Packet Guide
City of Charlottesville
Board of Architectural Review
Regular Meeting
May 20, 2025 5:30 p.m.
Hybrid Meeting (In-person at Council Chamber and virtual via Zoom)

Certificate of Appropriateness Application

Certificate of Appropriateness Application

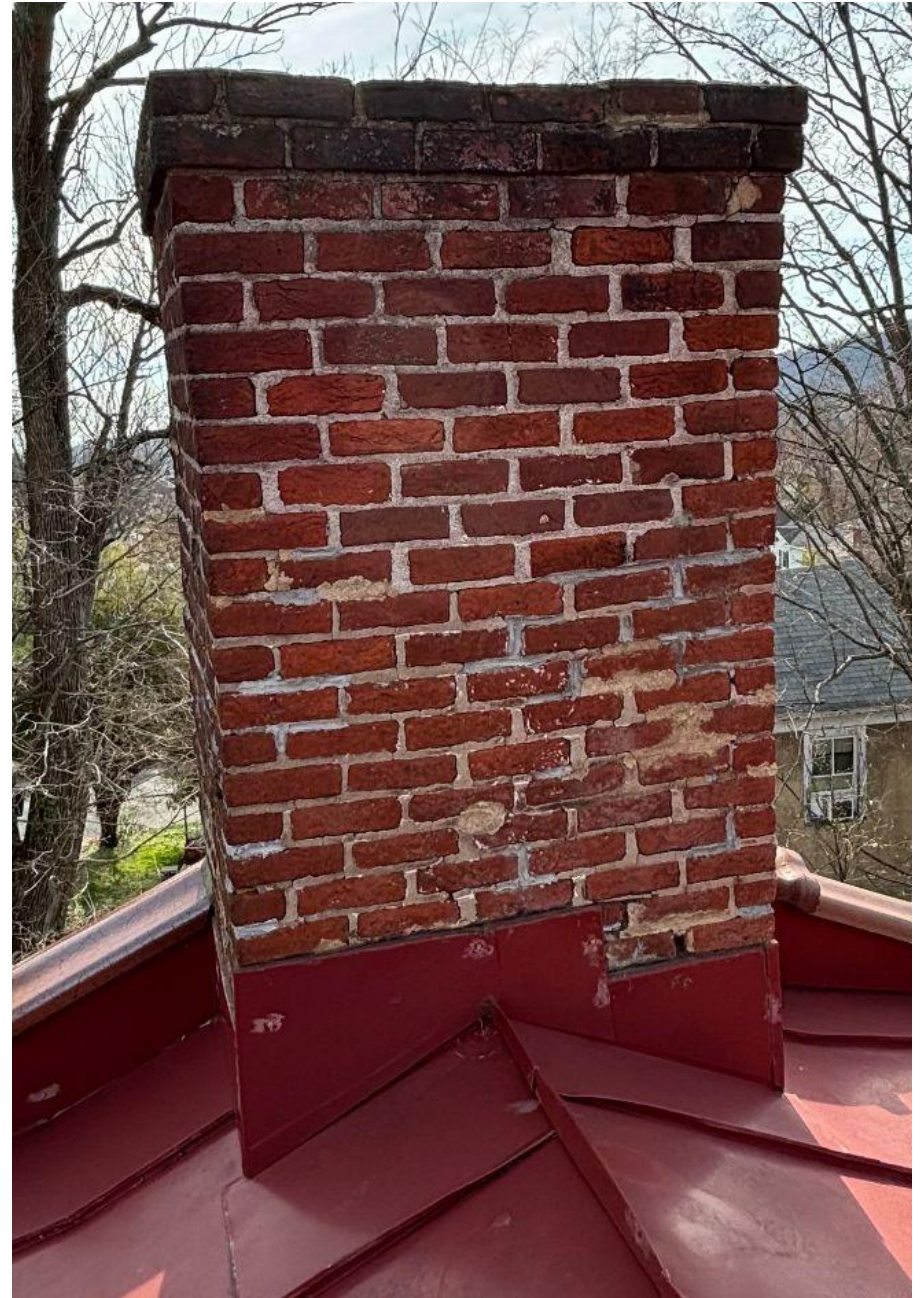
My assessment of the chimney in question is that it is in very poor condition. The mortar joints have no structural integrity at this point and have actually turned into dust in most of the chimney causing the brick to slowly lean approximately 4 inches towards the house. It is positioned on the gable end and while there's little to no danger of the chimney falling towards the driveway, it will inevitably fall onto the roof if it is not addressed in the immediate future.

Our plan is to remove the chimney down to the peak of the gable, capping it off with a metal dome and installing vents through the dome to allow the furnace to vent properly. Our removal process will involve scaffolding up to the chimney and removing the brick onto the scaffolding and lowering them down using a rope and pulley system.

- Remove the chimney down to stable masonry [brick and mortar], then reconstruct it either reusing the historic bricks, with appropriate mortar, or using new brick. The stability of masonry below the roof line is not known.
- Document the chimney with photographs and dimensioned sketches, to be submitted for the BAR archive. Remove the chimney down to the parapet. Repair/repoint exposed exterior brick at the parapet, as necessary. Cap the parapet similar to the work done at the west chimney, using painted, standing-seam metal and terra cotta coping.

Exterior View Window C-3

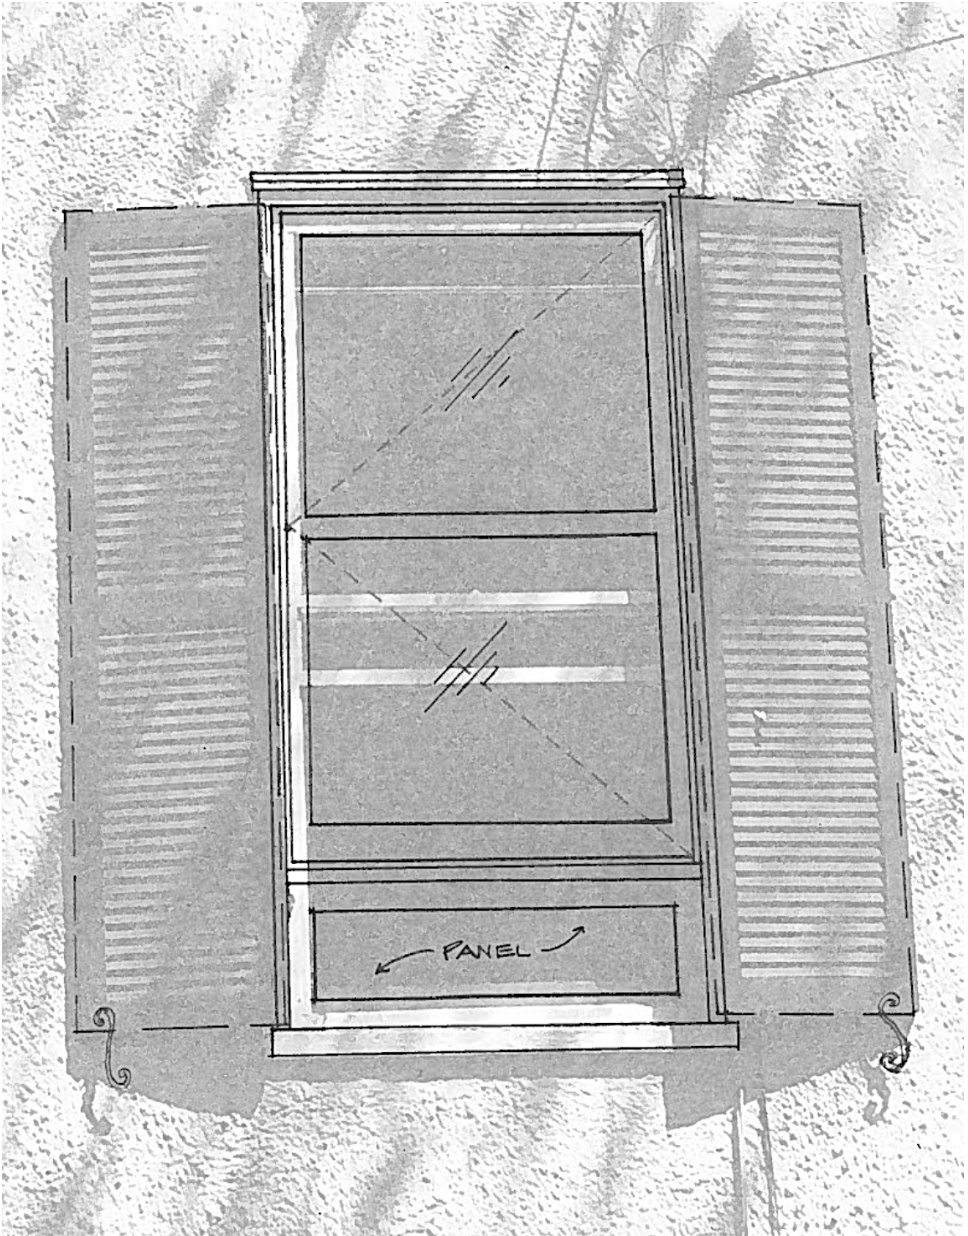
- e. Attic A-1: leave the existing half round hopper window in place.
3. In addition to the windows on the Park Street (West) Elevation, the owner is proposing a significant change to the South Elevation window C-3, for a more durable and usable window at new perimeter Kitchen counters. The proposal includes keeping the original exterior trim and sill but replacing the double hung with a shorter casement unit and a fixed panel below. Please see the attached sketch.

UPPER LEVEL B-9
SCALE: 3/4" = 1'-0"

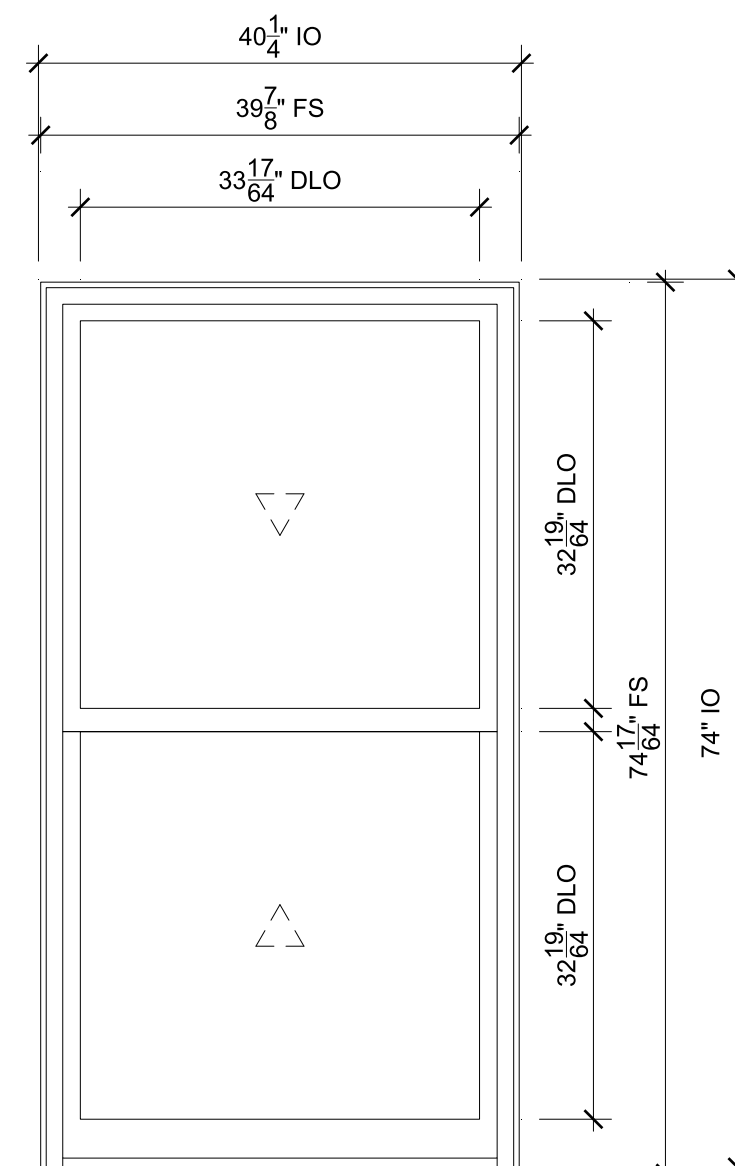
- c. Upper Level B-9: replace the existing double hung in this bedroom suite with double hung.
 - d. Upper Level B-10: replace the existing double hung in this bedroom suite with double hung.
